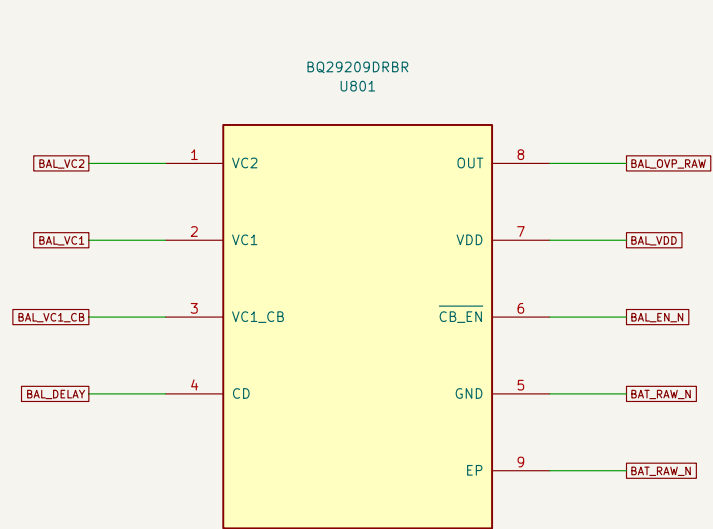
BAT_RAW_N is cell negative BEFORE a low-side protection switch. Never equate it with USB_GND/PACK_MINUS. BAL_EN_N defaults OFF. External enable/OVP interfaces need battery-domain isolation/level translation.

OUT is active HIGH (up to 9.5V in specified conditions), not open drain. No direct FAULT_BUS_N connection.
OVP is secondary 4.30V, not a 4.20V cell regulator. BQ25886+A is still incomplete.
No fuse/FET actuator, low-voltage enable policy, PCB, physical balancing or LW charge performed.
